ADDENDUM NO. 1
TO THE BID DOCUMENTS FOR:

JEFFERSON PARISH SHERIFF'S OFFICE
WAREHOUSE TORNADO REPAIRS
1801 WESTBANK EXPRESSWAY
HARVEY, LOUISIANA 70058

Jefferson Parish Bid No.: 23-JULY-1701

JULY12, 2023

2
A-2.1 A-2.4
NEW ENLARGED FLOOR PLAN - PROPERTY & EVIDENCE, WASHROOM
SCALE: 1/2"=1'-0"

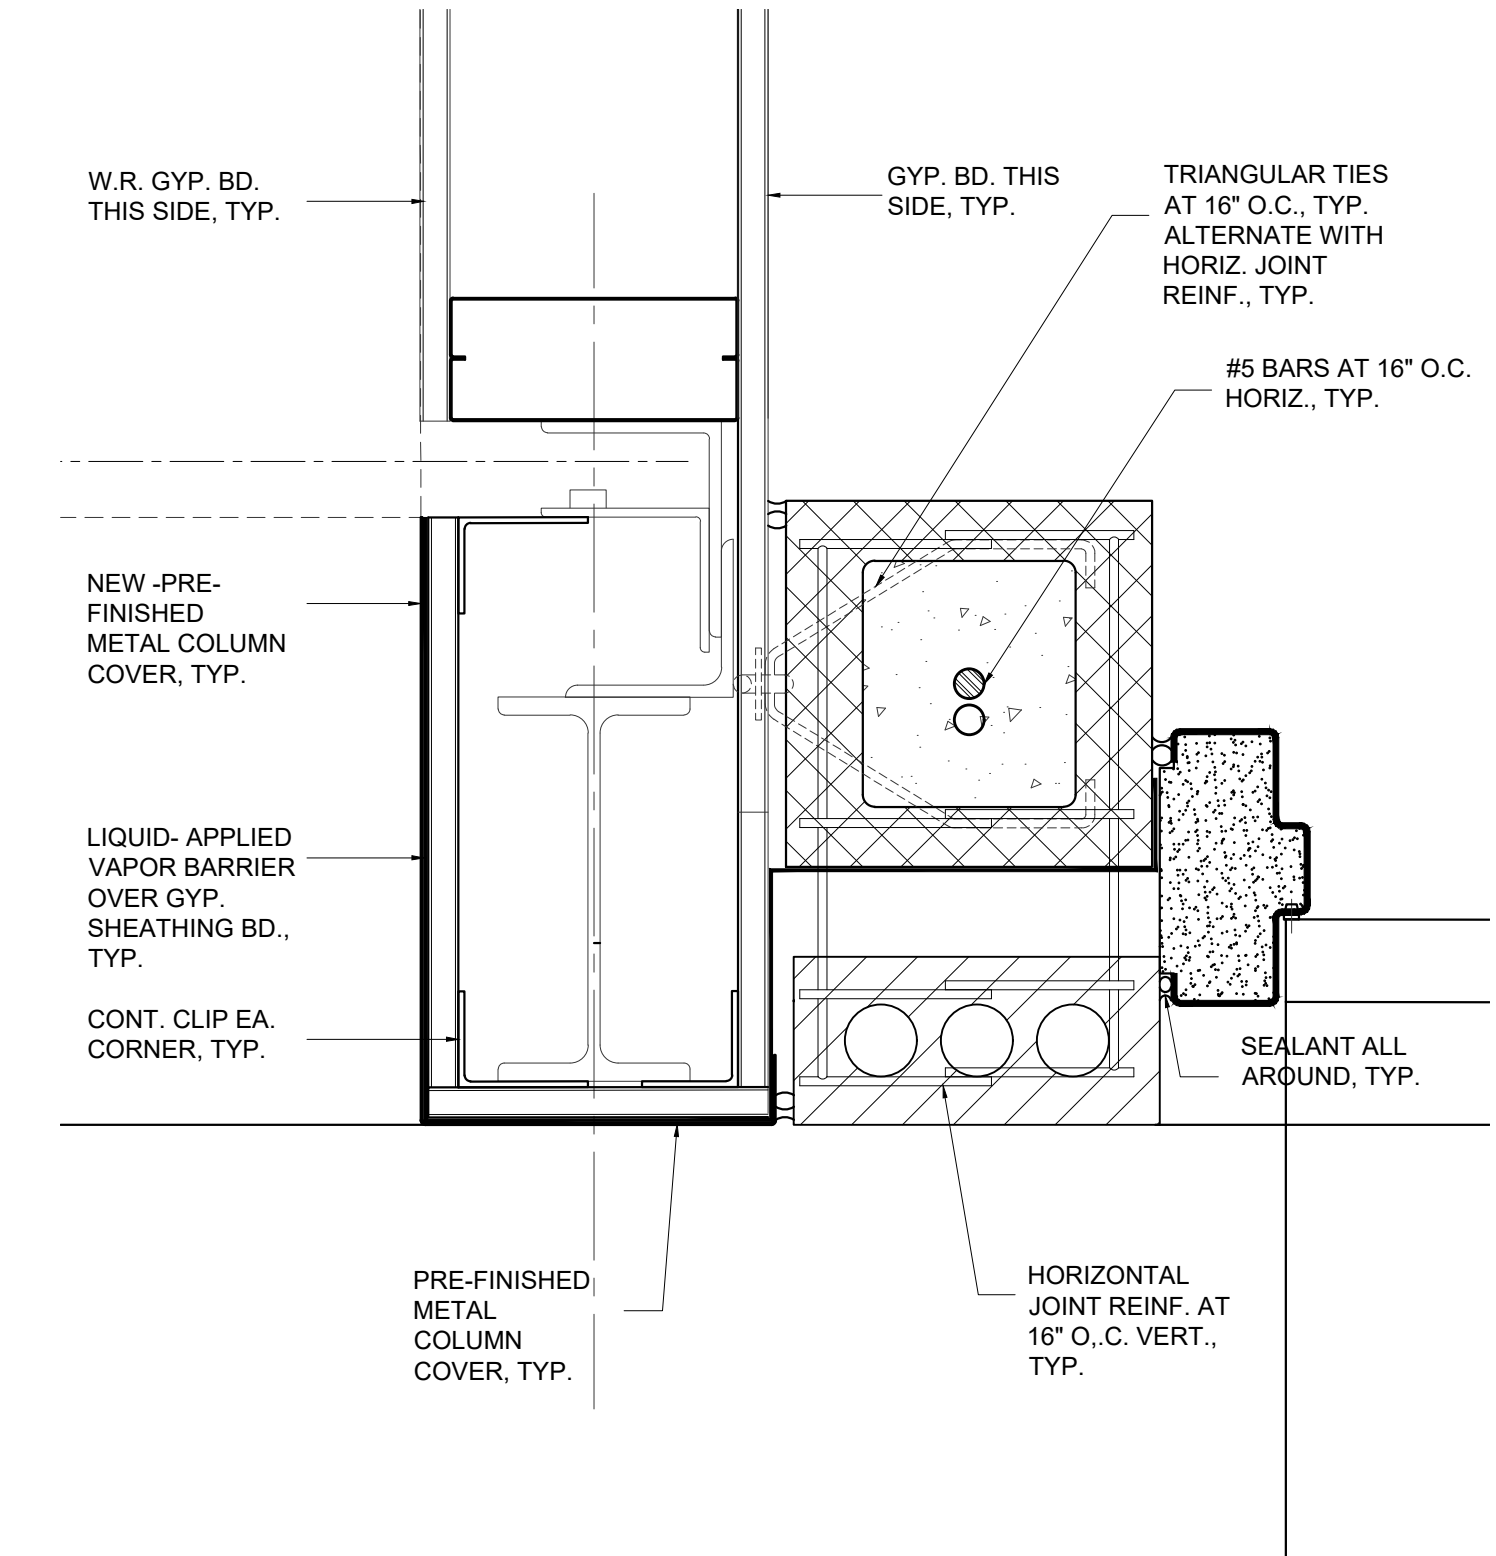
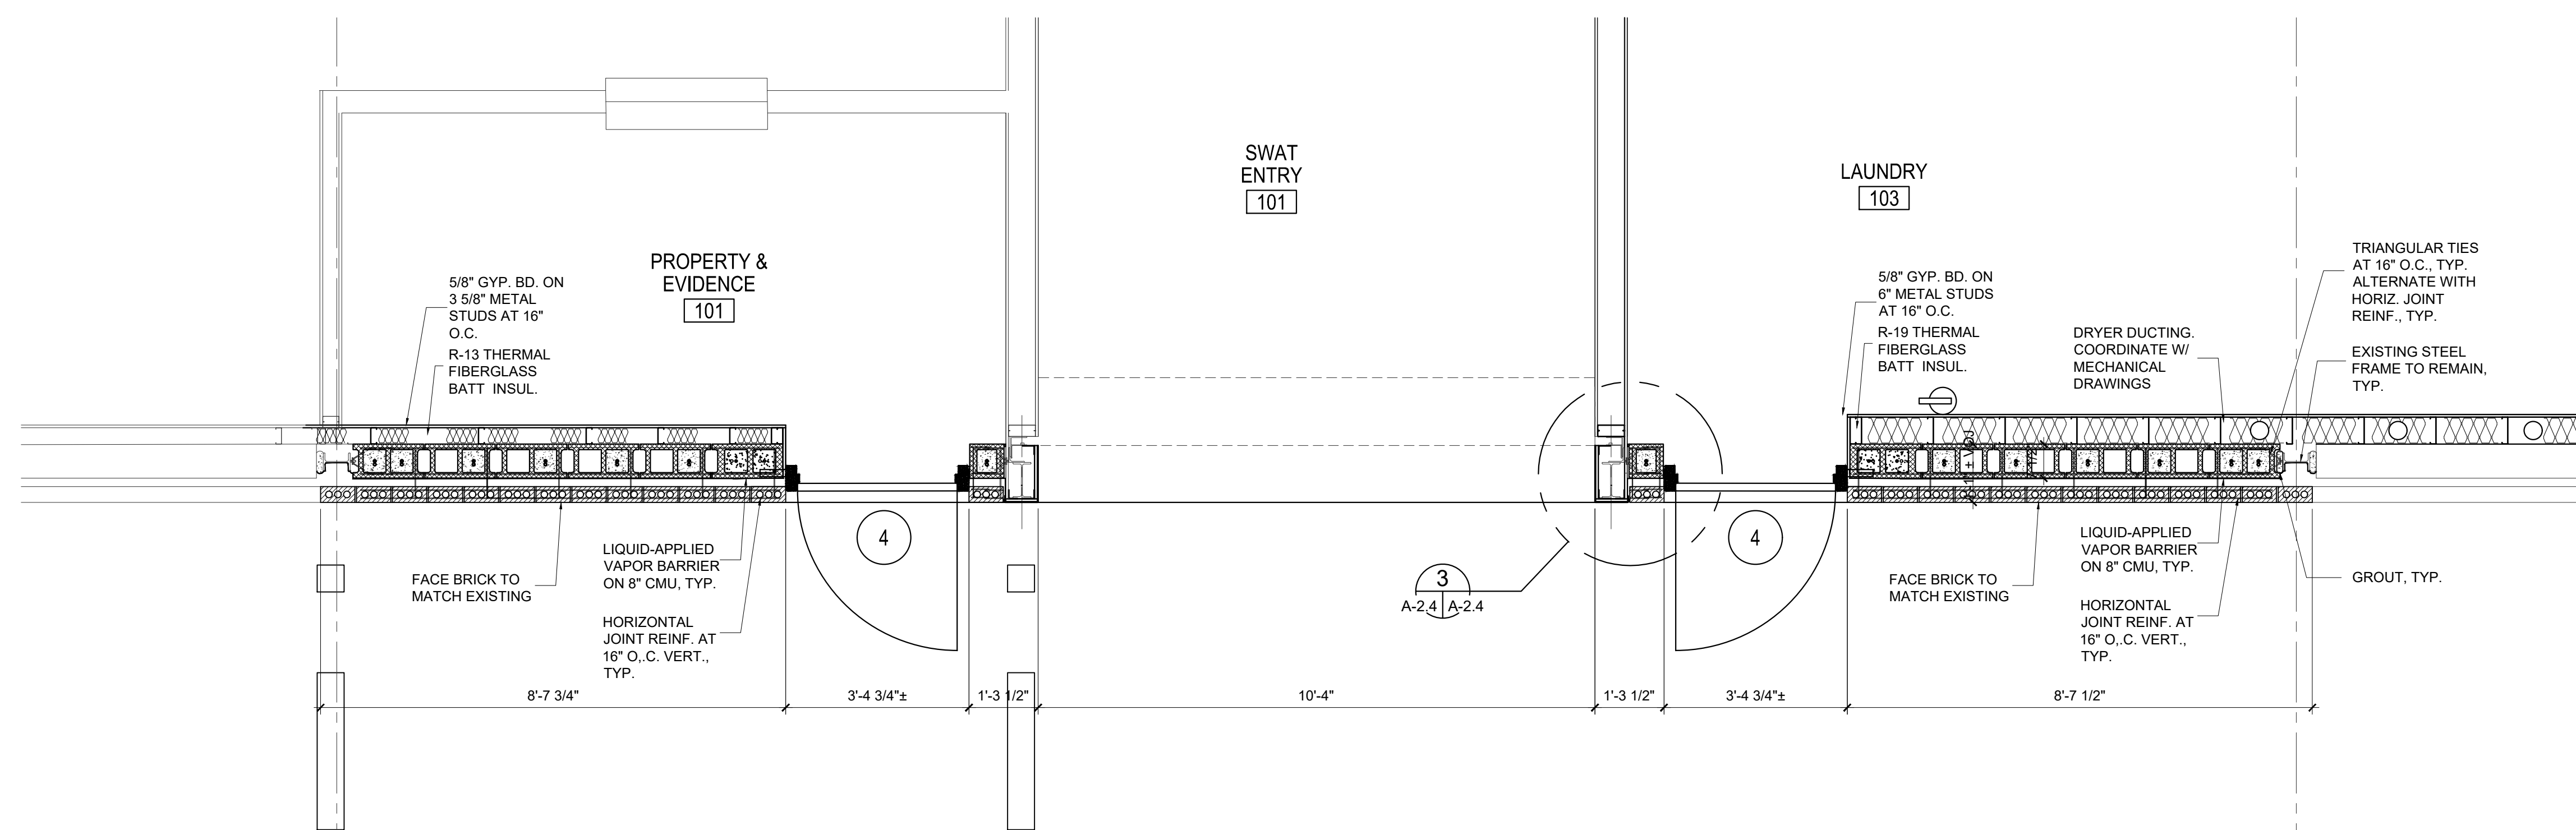
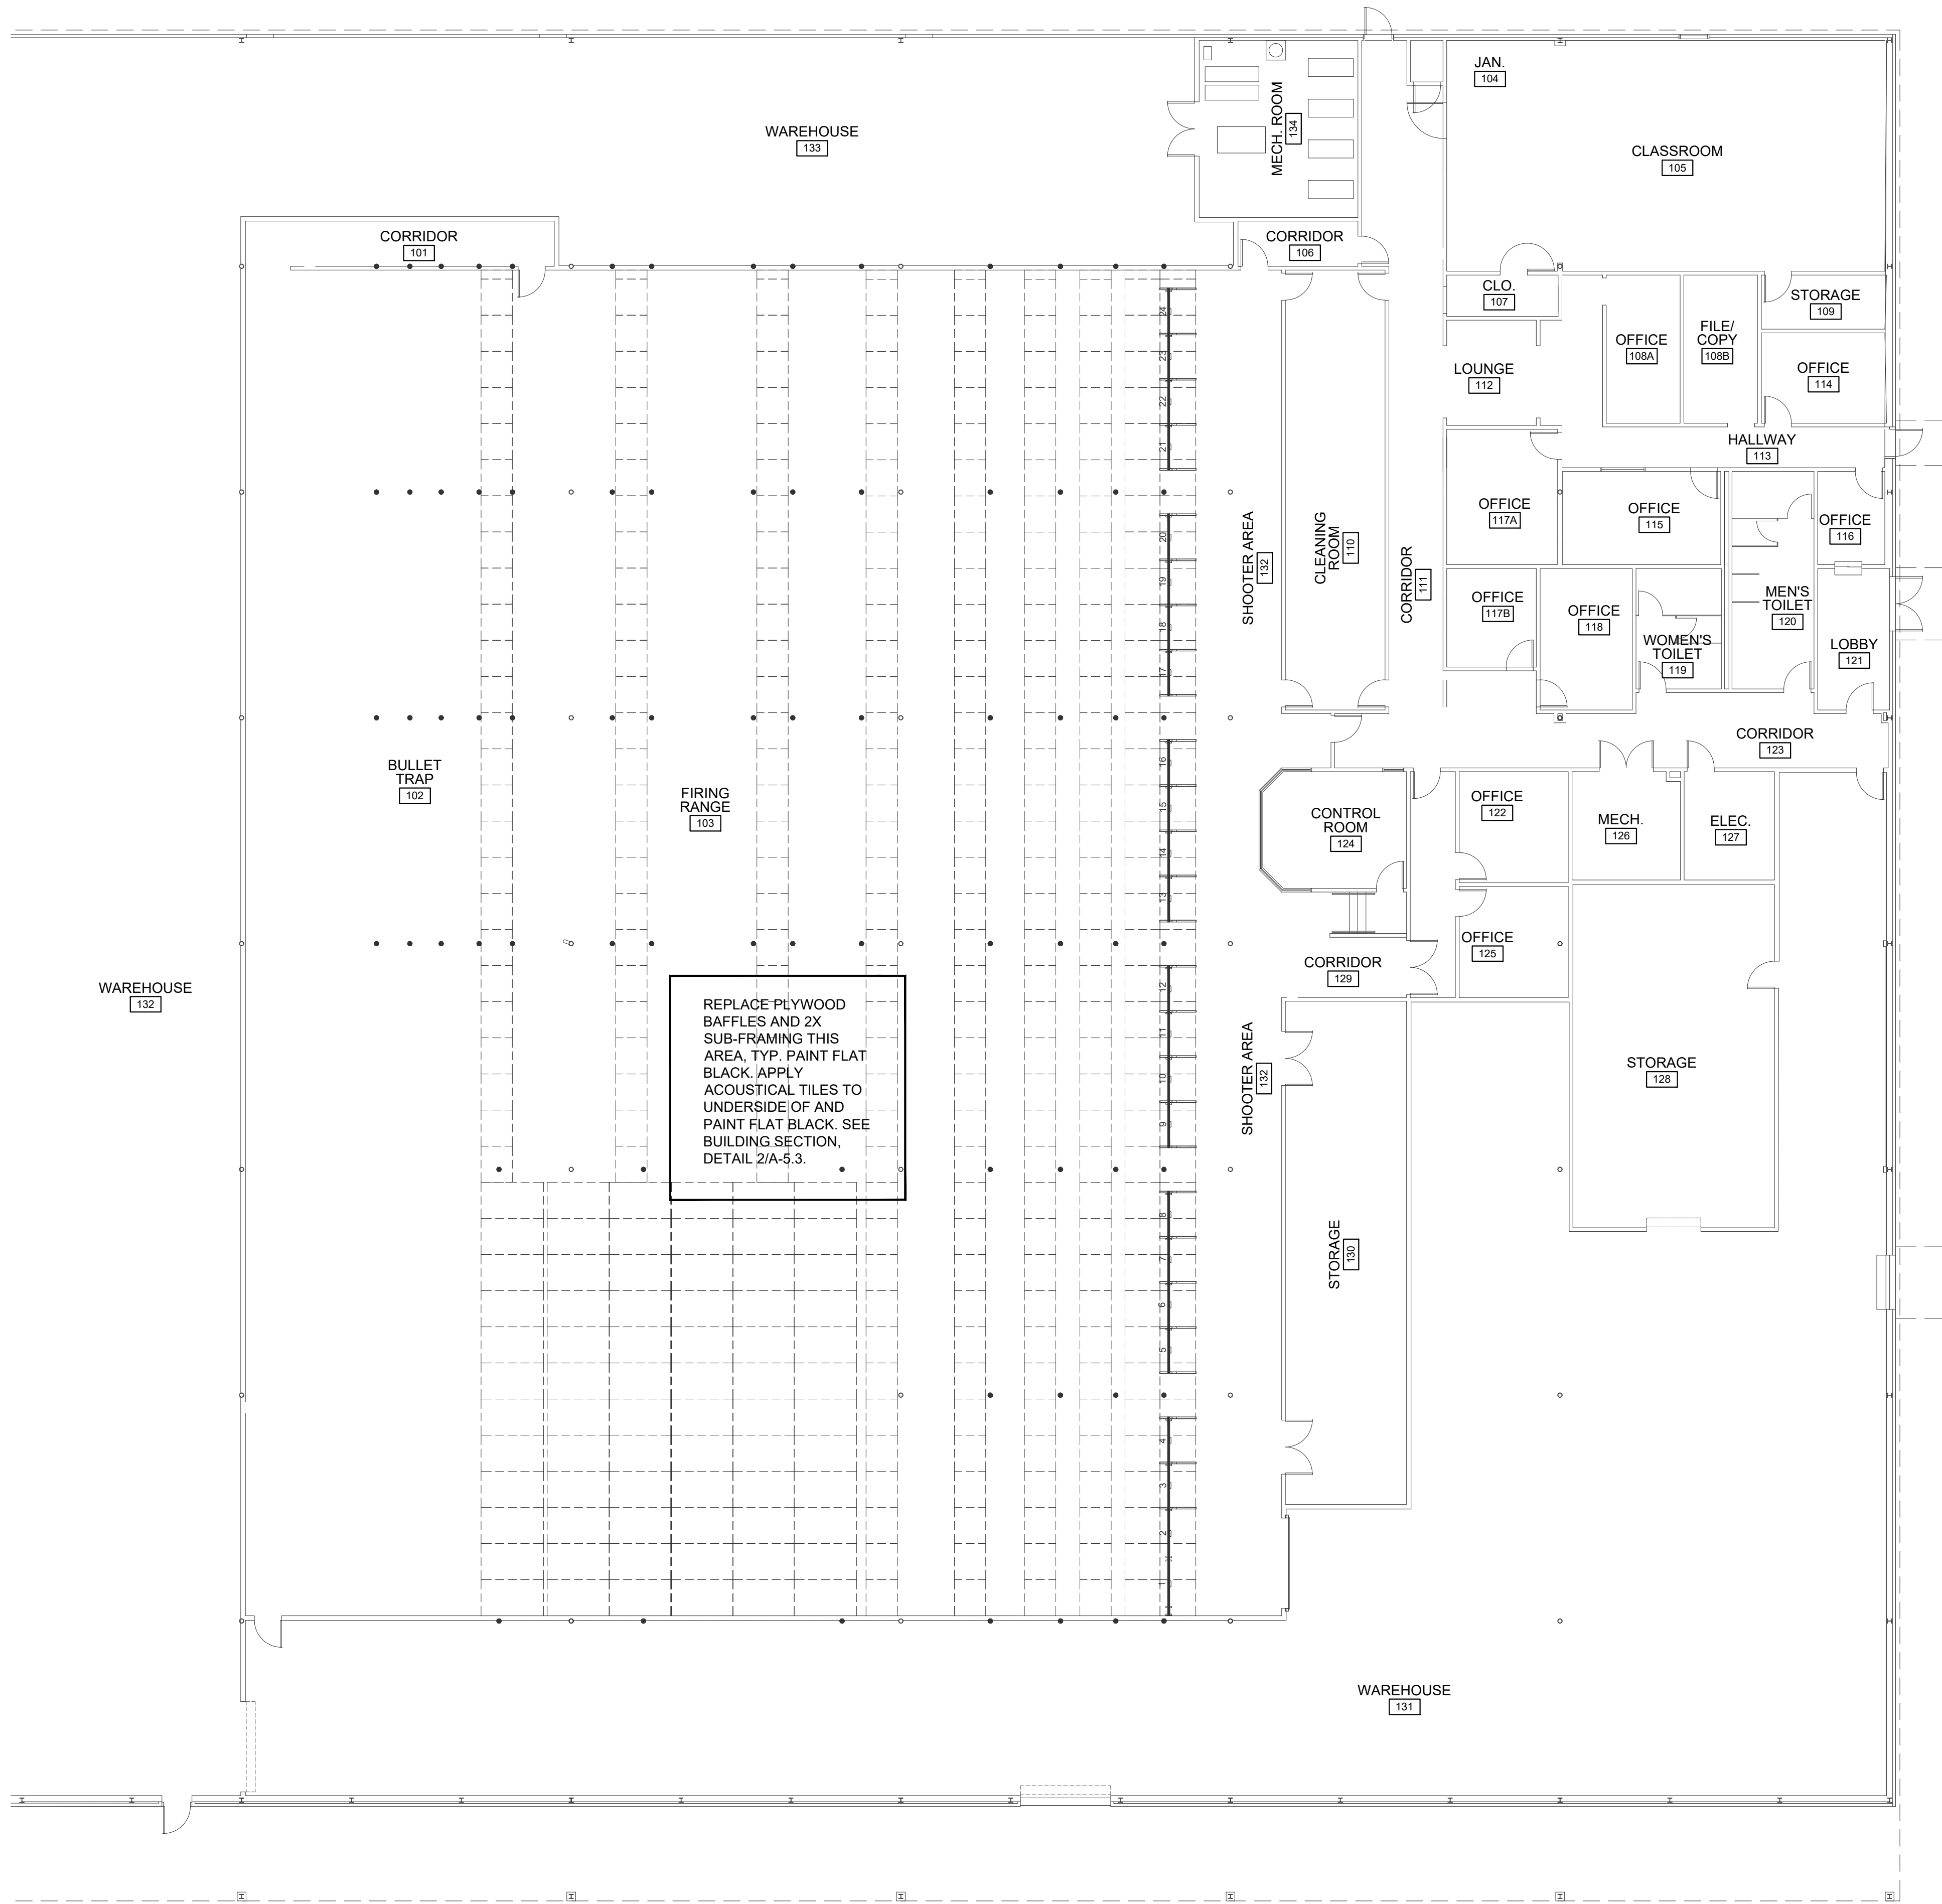
1. **Sheet A-2.3:** Delete Reference to **Door 3** and **Window A** at **Laundry 103**. Demo **Aluminum Storefront**. At **Property & Evidence Office 101**, and **Laundry 103**. See **New Sheet A-2.4**.
2. **Sheet A-12.2:** Omit Reference to "Existing Aluminum Storefront to Remain" on Elevation 2/A12.2 at **Laundry 102**.
3. **Sheet A-2.4:** Add **New Sheet A-2.4**. **Sheet A-2.4** clarifies the Demolition Work for removal of the Existing Aluminum Storefront at the Property & Evidence Office, and Washroom. Add two **New Exterior Hollow Metal Doors Type 4**, **Hollow Metal Door Frame Type 2**, and **Hardware Set 4**, with reference to **Details 10, 11 & 12/A-7.6**.
4. **Sheet A-4.1 (Building Letters):**

REFLECTED CEILING BAFFLE PLAN - FIRING RANGE

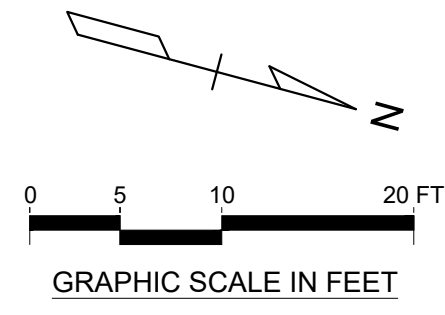
Owner will provide New Dimensional Signage.
5. **Sheet A-7.8:** Add **New Sheet A-7.8**. Replace Plywood and 2x Wood Sub-Framing. General Contractor to remove and replace all Plywood and 2X Wood Sub-Structure on the Existing Baffles to access the existing metal surfaces to be sandblasted. For purposes of Bidding, include 2x4 Wood Sub-Framing along each line shown on the Baffles, as shown on Sheet A-7.8, and 1/2" Plywood on the Bottom Face of the Baffle. Also See Building Section Detail 2/A-5.3. Paint Flat Black. Apply 12"X12" Acoustical Tiles on the Bottom Surface of the Plywood with Adhesive. Paint Acoustical Tiles Flat Black.

REPLACE PLYWOOD
BAFFLES AND 2X
SUB-FRAMING THIS
AREA. TYP. PAINT FLAT
BLACK. APPLY
ACOUSTICAL TILES TO
UNDERSIDE OF AND
PAINT FLAT BLACK. SEE
BUILDING SECTION.
DETAIL 2/A-5.3.
